Technical Service Bulletin

BE-0090L-0915

Lexus premium navigation - wiping marks on audio navi multidisplay screen after cleaning

IS250; IS300H; RC F; RC350

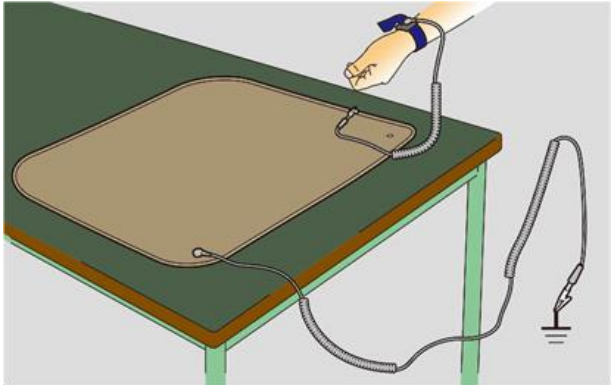
The production method to coat the multi-display screen with an anti glare coating has changed to ensure a better adhesion of the anti glare coating to the screen.

Previous part number	Current part number	Part name	Quantity
86110-53010	86110-53011	Multi-display assy	NA
-	86134-53030	Parts, Multi display	1

1. Order the repair kit 86134-53030 (See "Parts information")
2. Remove the multi-display assembly from the instrument panel. To remove the multi-display assembly from the instrument panel consult the vehicle's repair manual.
3. Replace the front cover of the multi-display assembly by the new front cover from the repair kit according to the below rework instruction.
